CITY OF HOPEWELL

Hopewell Regional Wastewater Treatment Facility Alternative 4A-1 Light Phase 2 Improvements

Results of Value Engineering Concepts Evaluation

APRIL 30, 2014

YARD PIPING PLAN 2

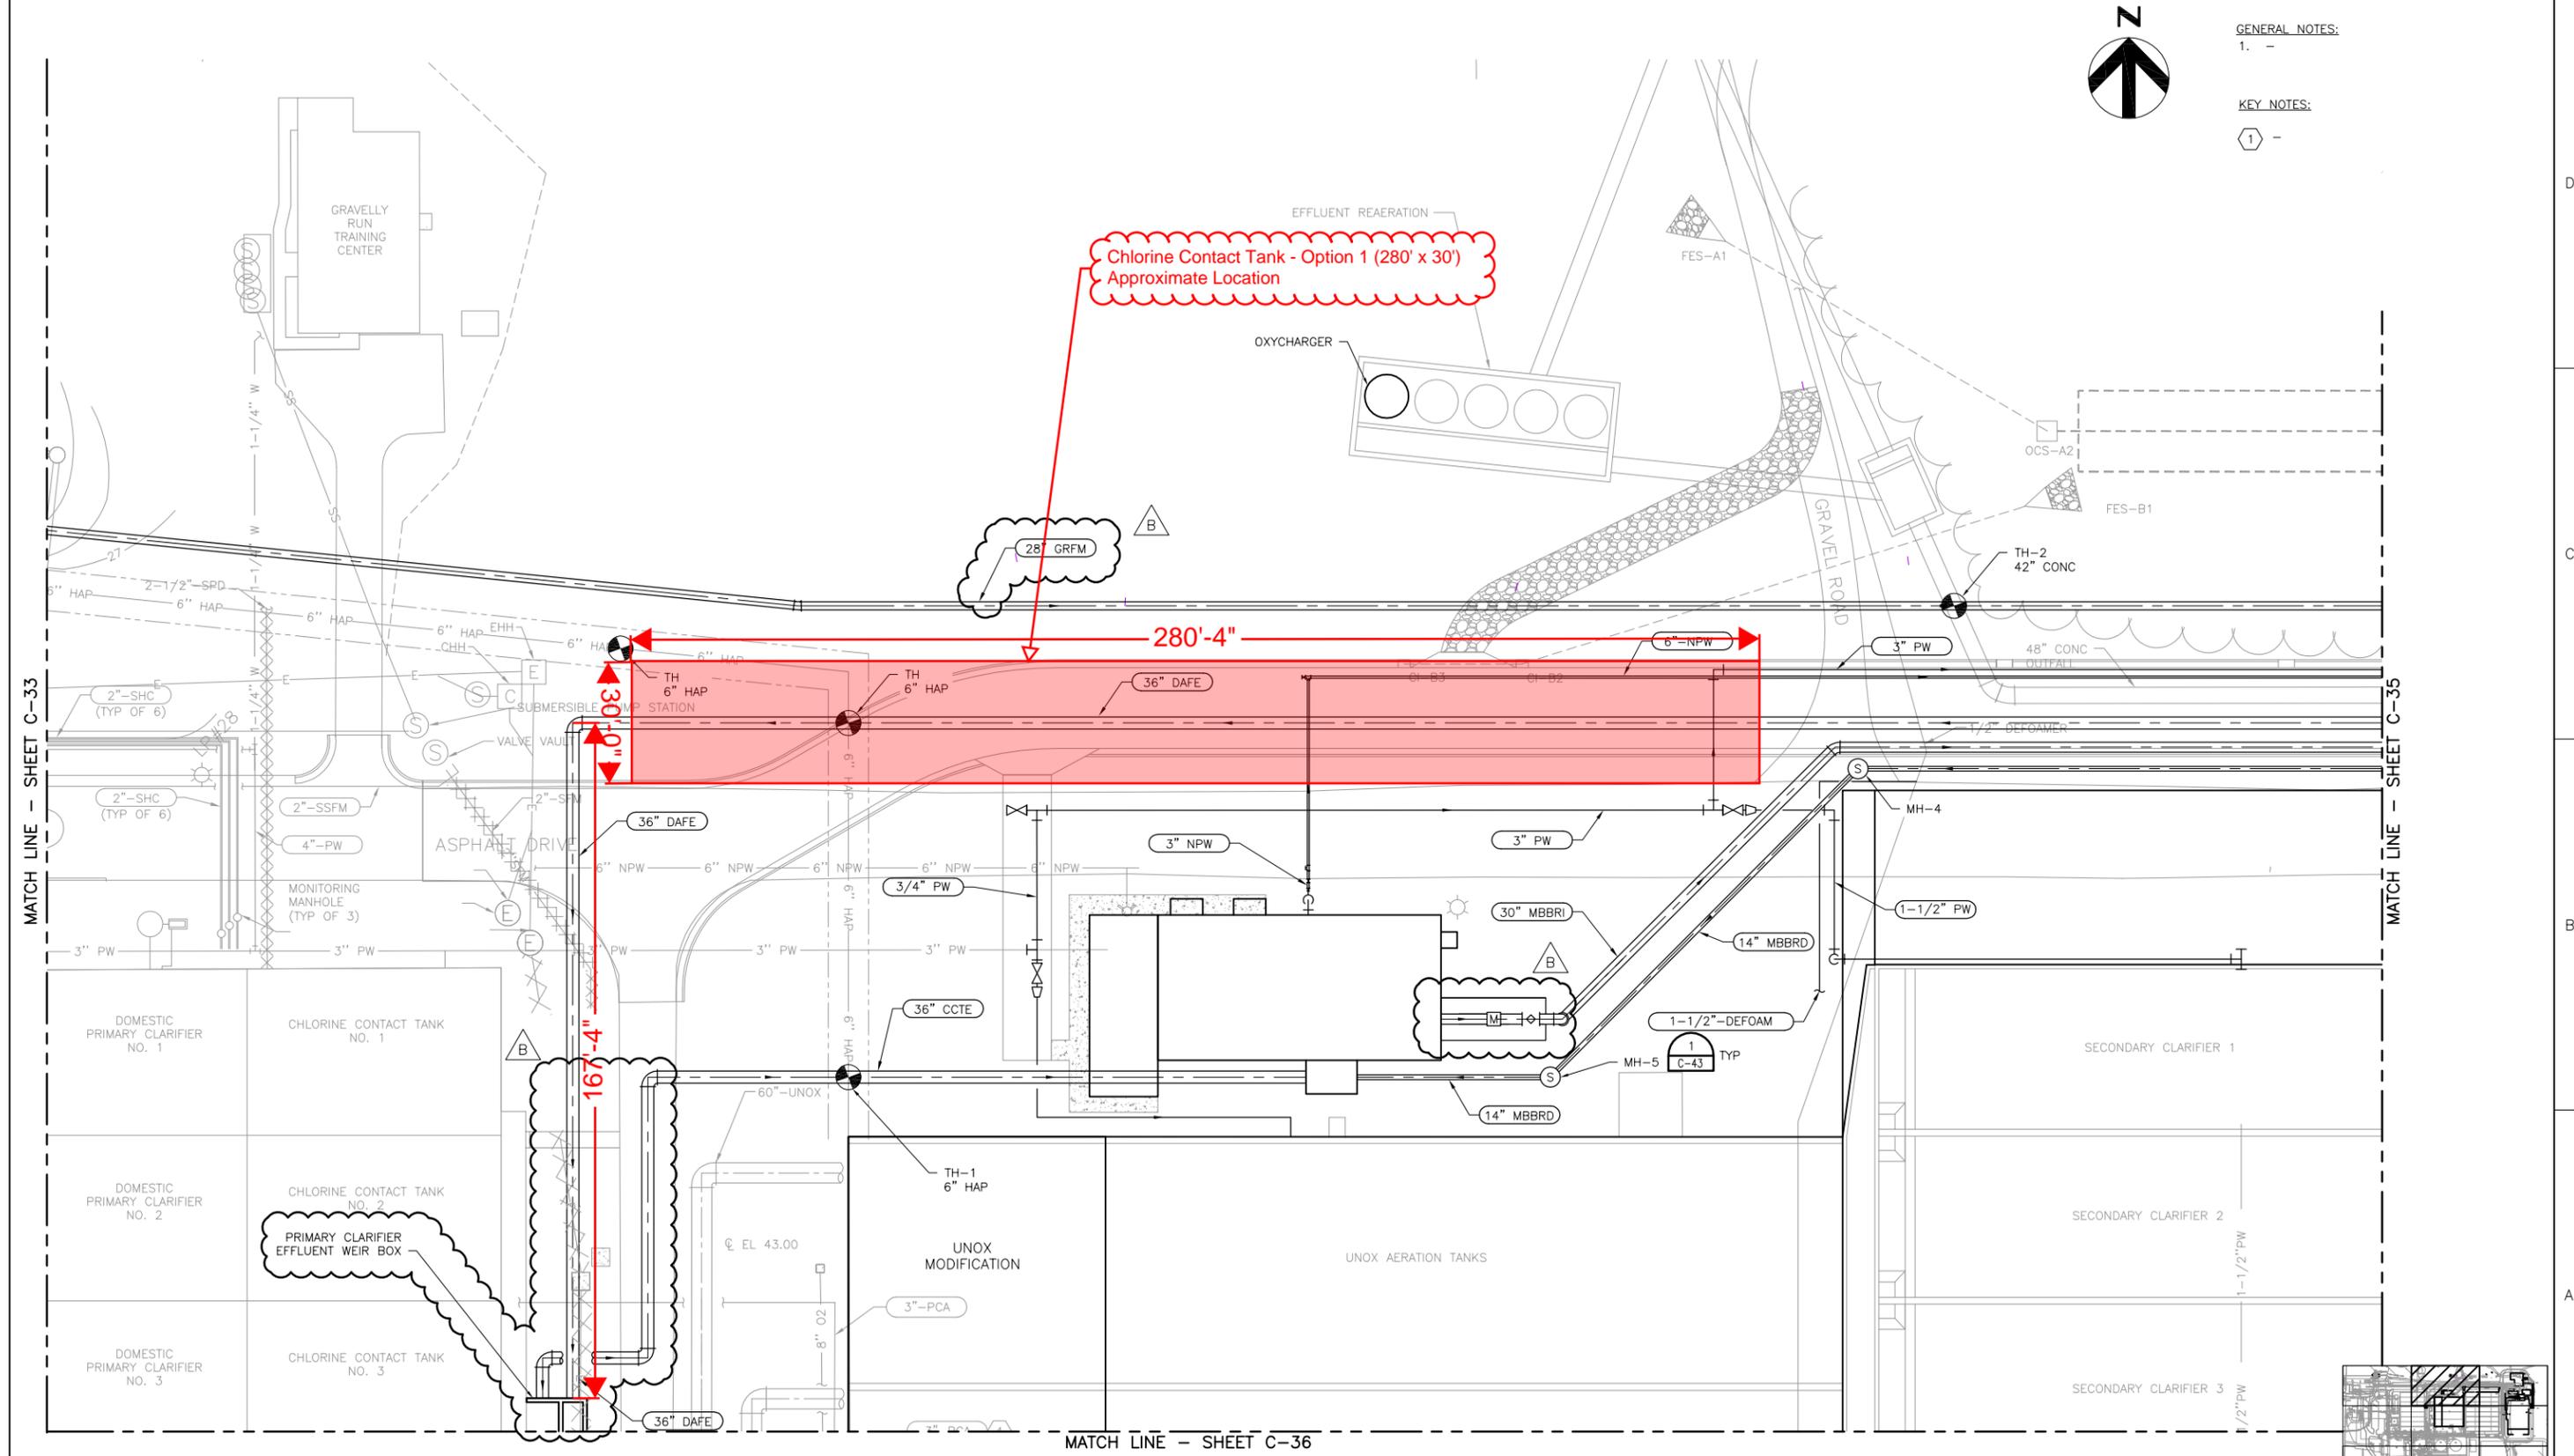
The current design proposed by HNP has the flow control valves located on the plant site as depicted on Drawing C-33 rev 3 entitled "Yard Piping Plan 1". Flow control valves will control Honeywell flow diversion between the new segregated MBBR treatment system and the existing Industrial headworks. A fine screen is provided to protect the MBBR treatment system. This VE alternative proposes relocating the flow control valve to a location off site in the area near the connection of RockTenn flow into the North Interceptor. The Honeywell flow will connect to the domestic influent line near Hummel Ross Road and to the North Interceptor near the Rock Tenn connection.

- 1) A new Chlorine Contact Tank (CCT) would be constructed downstream of the DAFs and upstream of the Primary Clarifier Effluent Channel. The CCT would consist of two rectangular tanks measuring 260-feet long by 10-feet wide with a 12-foot side water depth.

- 2) Adding the new CCTs downstream of the DAFs requires the DAF effluent line to be upsized from 36-inch to 42-inch to offset the additional headloss through the CCTs. In addition, the line from the new CCTs to the Primary Clarifier Effluent Channel will be 42-inch.

- 3) The new CCTs will be located north of the MBBR PS. This requires the new plant access road to be moved to the northern side of the new CCT. However, grading for the plant access road requires that a new retaining wall be constructed around the Effluent Reaeration Structure. A retaining wall is sufficient for the anticipated 9-foot differential grading and would be approximately 250-linear feet. Railing would be needed around the Cast-in Place Concrete retaining wall.

**MBBR INFLUENT PUMP STATION
AND SODIUM BISULFITE FACILITY
ELECTRICAL POWER PLAN**

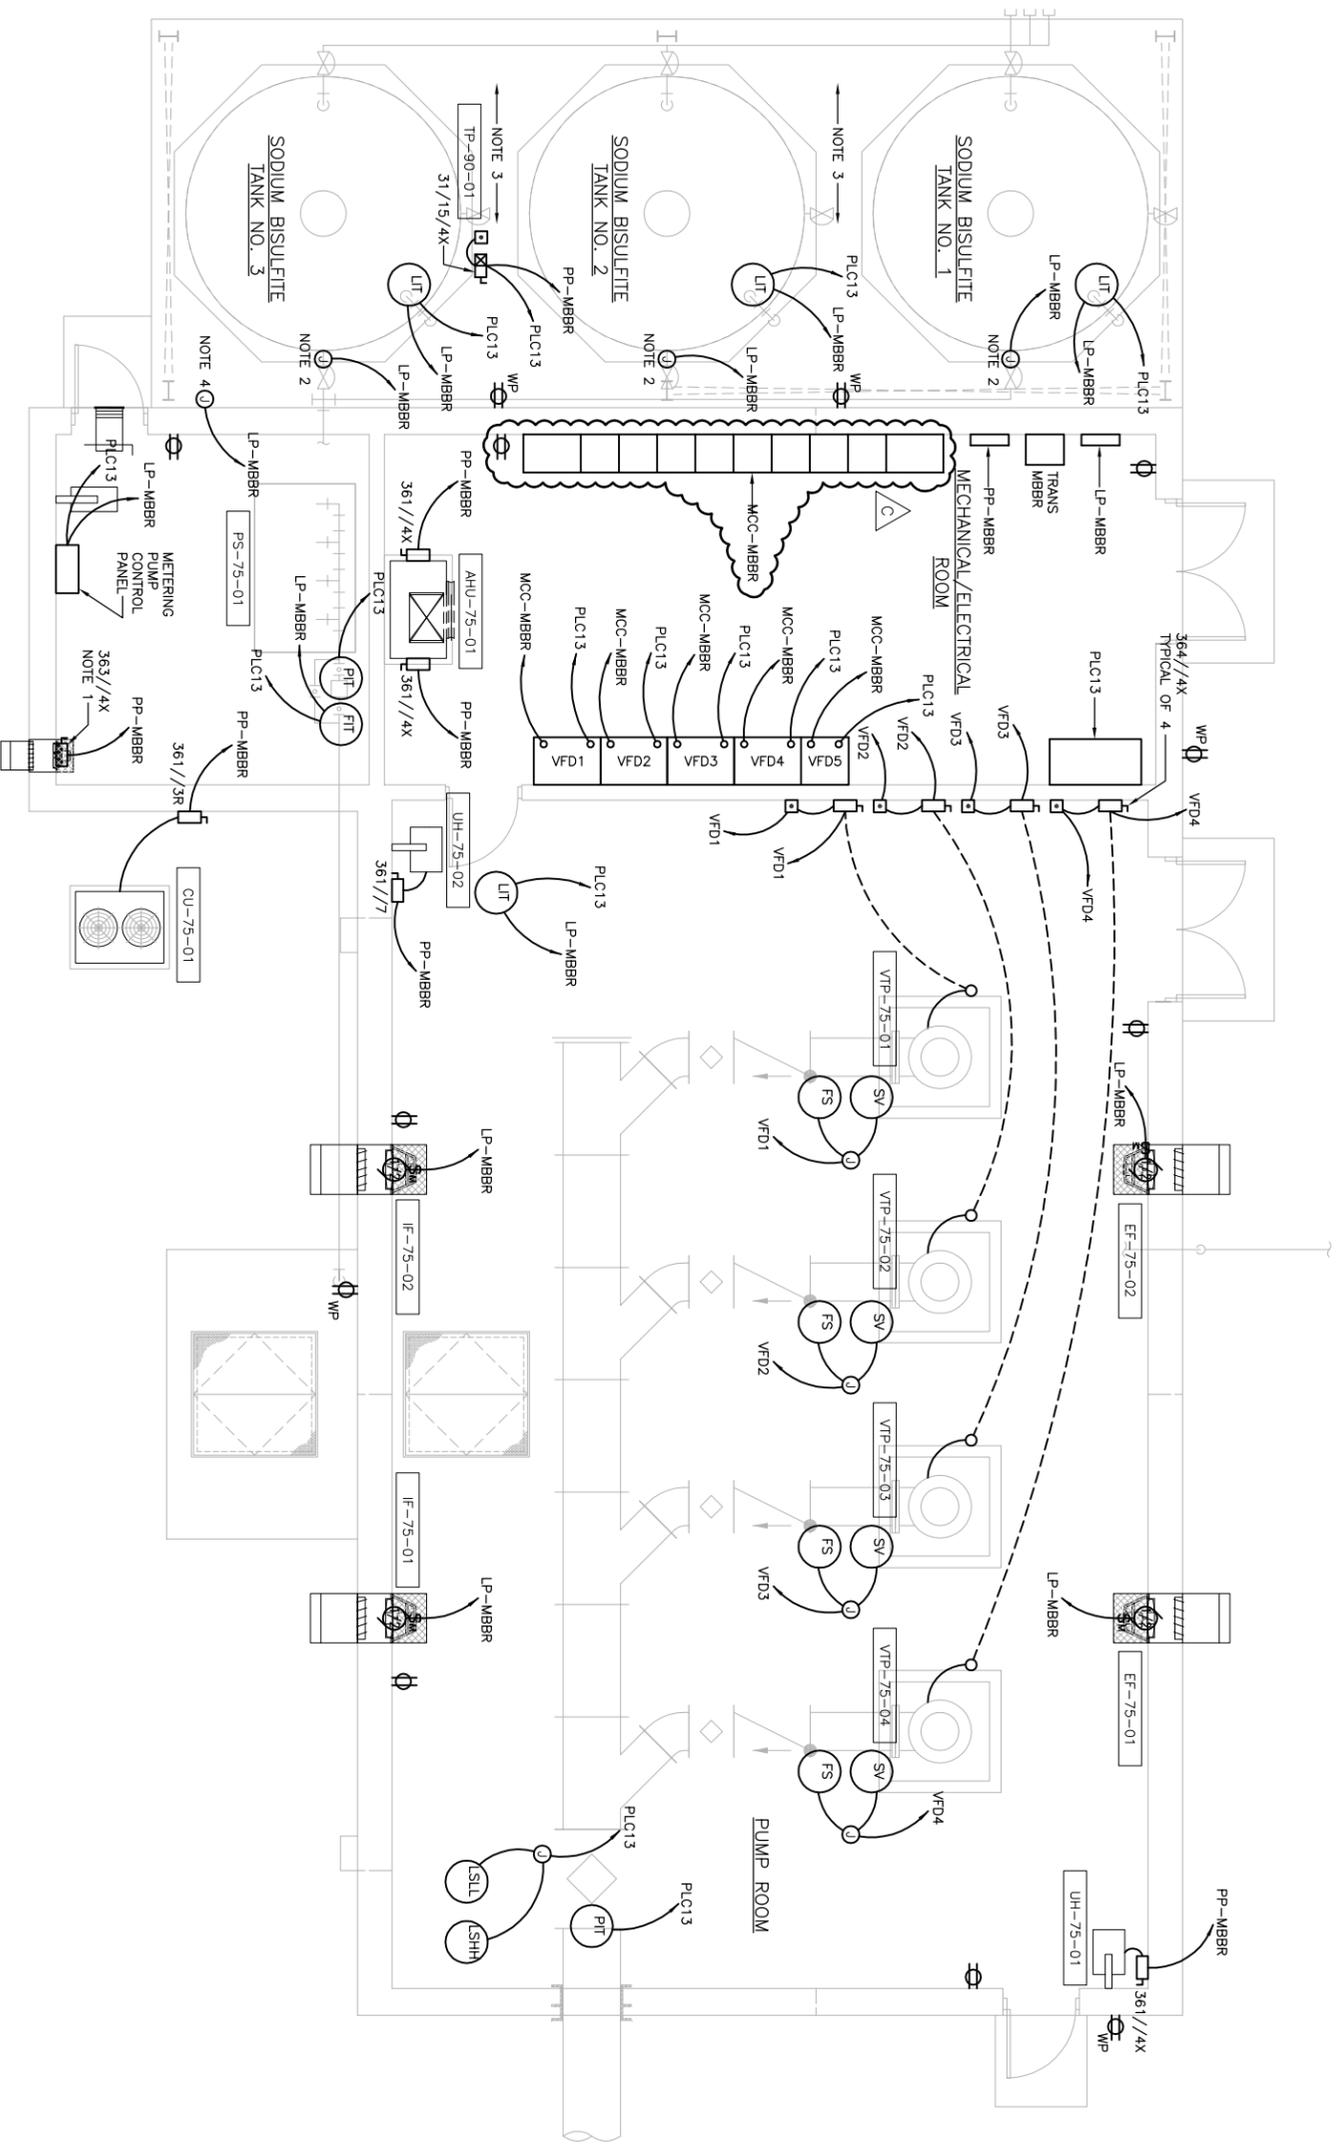
The current proposed electrical design configuration does not include redundant electrical services to the critical electrical distribution and motor control equipment. This VE alternate recommends that a “main-tie-main” configuration for the new 5 kV switchgear and motor control centers to minimize single point of electrical failure.

- 1) Main Tie-Breaker Switch and appurtenances

| | | CONCEPTUAL DESIGN | | CITY OF HOPEWELL HOPEWELL REGIONAL WASTEWATER TREATMENT FACILITY ALTERNATIVE 4A-1 LIGHT PHASE 2 | | MBBR INFLUENT PUMP STATION ELECTRICAL ONE-LINE DIAGRAM | |

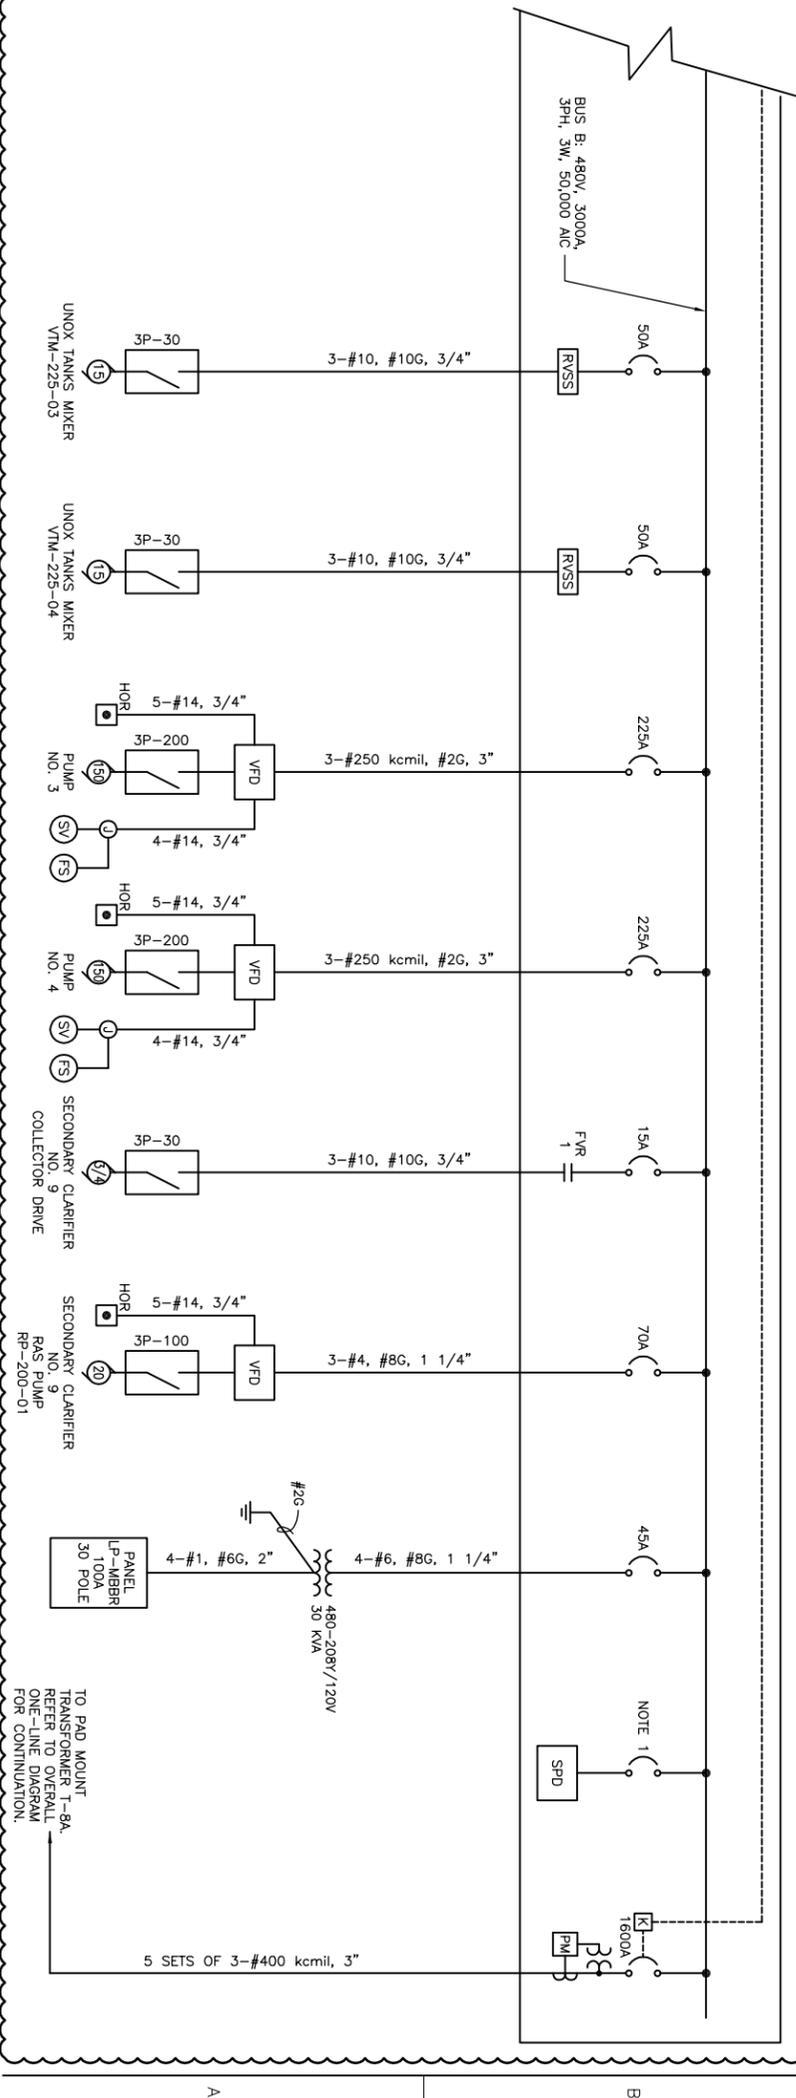
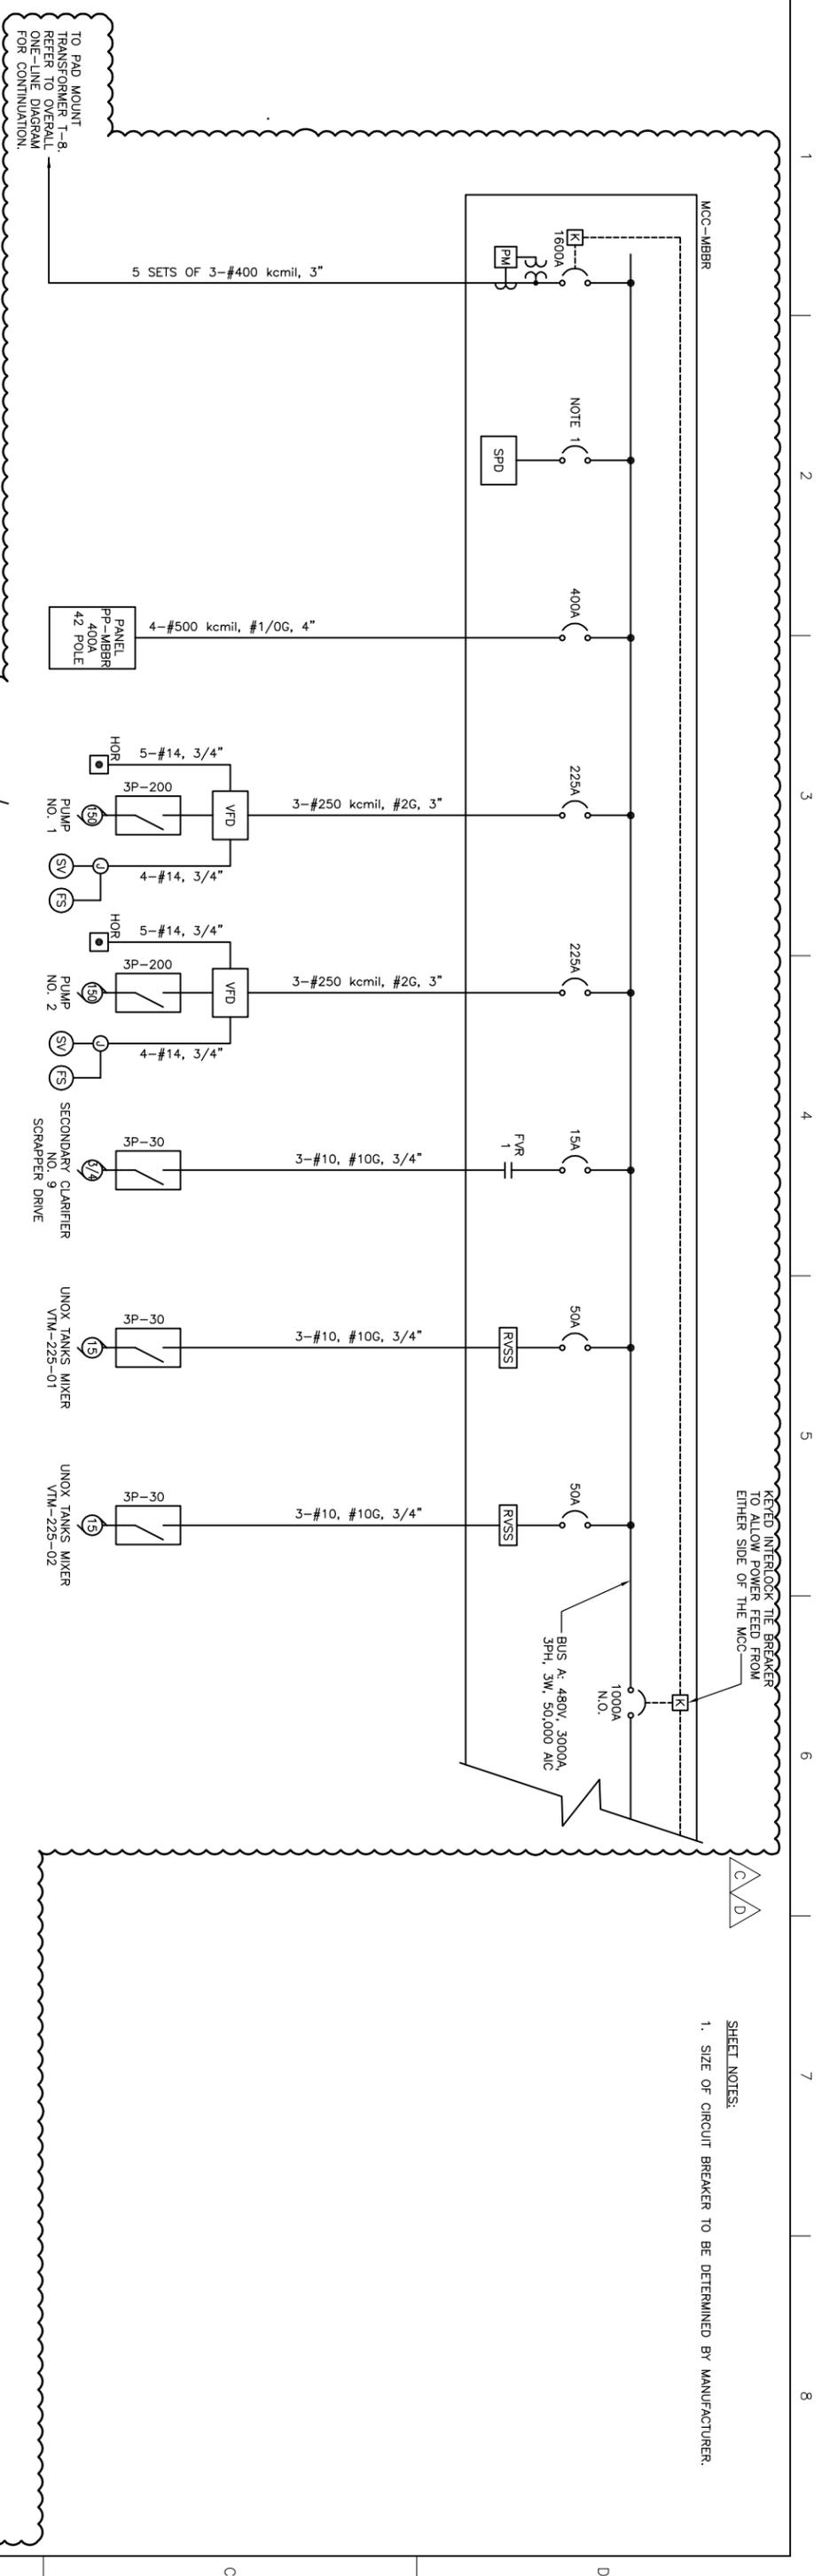
KEYED INTERLOCK THE BREAKER TO ALLOW POWER FEED FROM EITHER SIDE OF THE MCC
